project:
Tenant Finish
for
Brighton Recovery
Campus
4905, 4911, 4915, 4925,
4931, 4953 South 900 East
Salt Lake County, Utah

JANUARY 3, 2017	SECOND SUBMITTAL FOR EACH SEPERATE BUILDING PARCEL
JANUARY 6, 2017	ADDENDUM #2-BUILDING 'C'
JANUARY 17, 2017	ADDENDUM #4-BUILDING 'B'
FEBRUARY 24, 2017	ADDENDUM #7-BUILDING 'A'
MARCH 20, 2017	ADDENDUM #8-BUILDING 'A'

EXISTING
SITE PLAN

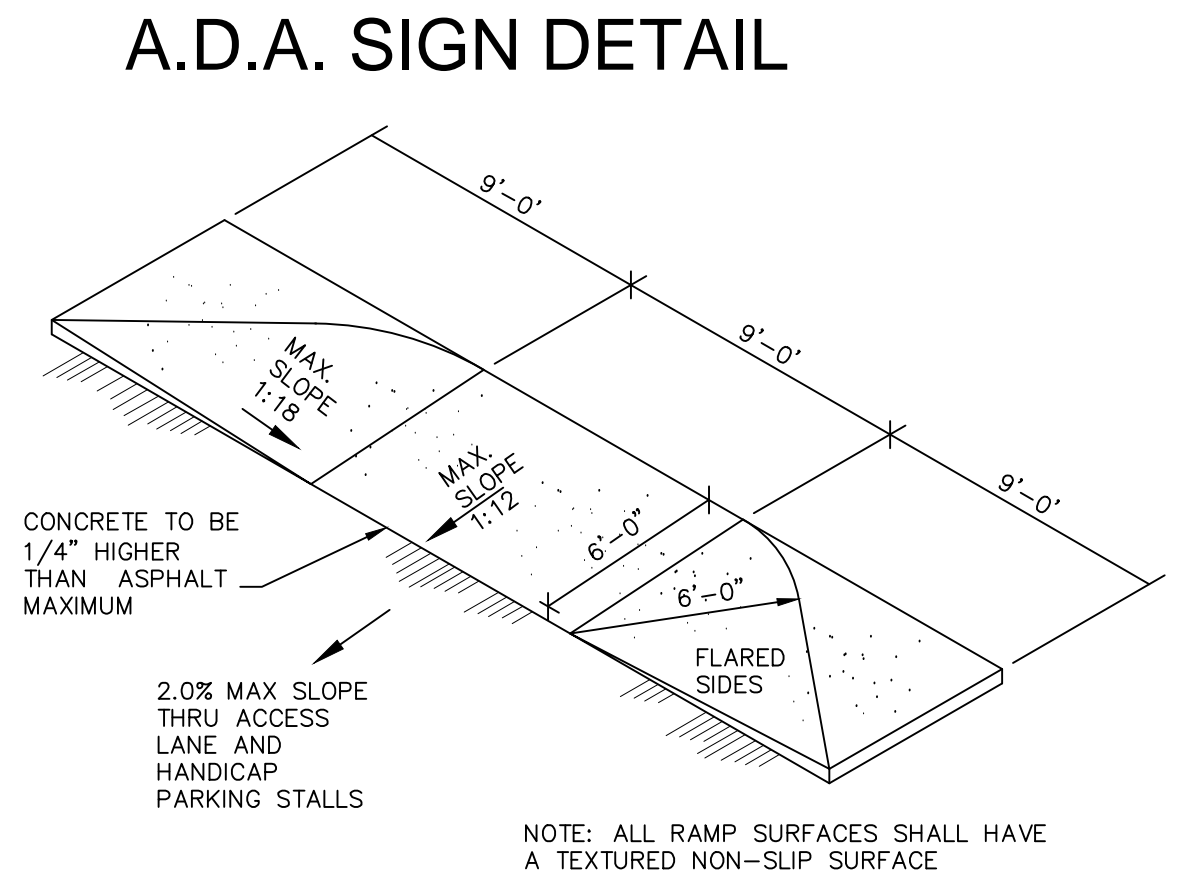
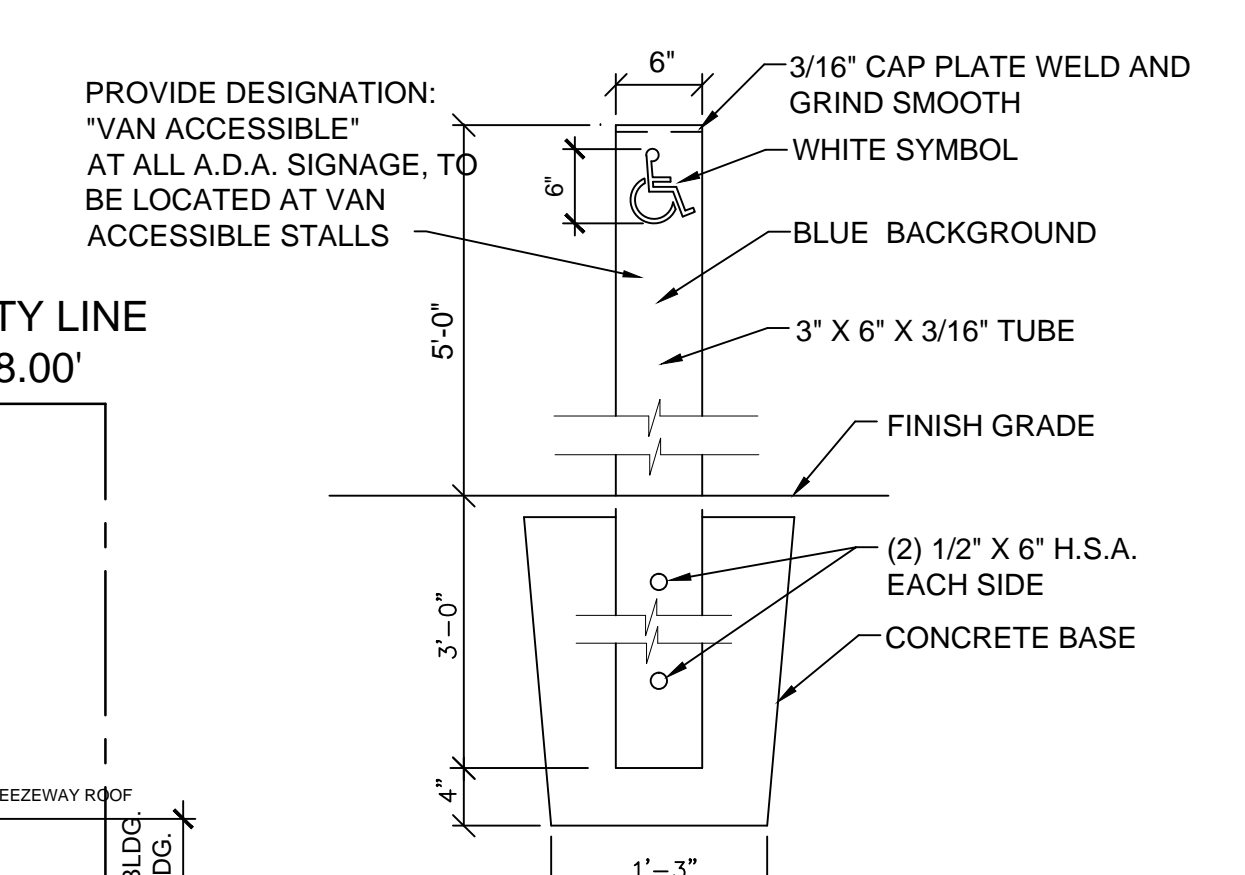
NOTE: ENTIRE EXISTING PARKING AREAS, INCLUDING DRIVEWAYS TO RECEIVE NEW ASPHALT OVERLAY AND NEW PARKING STALL STRIPING, AS PART OF ADDENDUM #4 -SEE NEW SPECIFICATION SECTION ON SHEET A1.2.

NEW ONE HOUR FIRE RATED WALL ASSEMBLY TO BE PROVIDED ABOVE NEW CEILING, ABOVE EXISTING EXTERIOR WALL STRUCTURE, WITHIN THE ROOF STRUCTURE OF EACH EXISTING BUILDING. THIS WILL OCCUR WHERE EXISTING ROOF OVERHANGS ARE ADJACENT TO OTHER EXISTING BUILDING ROOF OVERHANGS, AND WHERE EXISTING BREEZEWAY ROOFS OCCUR. WALL ASSEMBLY TO EXTEND FROM BOTTOM OF EXISTING ROOF OVERHANG TO BOTTOM OF EXISTING ROOF SHEATHING. UL DESIGN U305, OR U314: 5/8" SHEETROCK FIRECODE CORE PANELS, OR 5/8" SHEETROCK ULTRALITE PANELS FIRECODE X, OR 5/8" FIREROCK PANELS ON 2X4 WOOD STUDS @ 16" OR 24" O.C. (ONE HOUR FIRE RATED CONSTRUCTION). THIS ALLOWS A FIRE RATED SEPERATION BETWEEN EXISTING BUILDING CANOPIES AND BREEZEWAY ROOF STRUCTURES. THIS FIRE RATED WALL ASSEMBLY WILL EXTEND FROM THE TOP OF THE ROOF BEARING WALL STRUCTURE, TO THE BOTTOM OF THE EXISTING ROOF SHEATHING.

ALSO PROVIDE NEW FIRE SPRINKLING SYSTEM AT ALL EXISTING BUILDING EXTERIOR ROOF OVERHANG SOFFITS AND BREEZEWAY SOFFITS. FIRE SPRINKLING SYSTEM TO BE NFPA 13 SYSTEM, AND TO MEET ALL LOCAL JURISDICTION AND NATIONAL REQUIREMENTS. REFER TO SHEET P02 FOR FIRE SPRINKLING SYSTEM REQUIREMENTS. SYSTEM TO BE DESIGNED FOR EXTERIOR APPLICATION
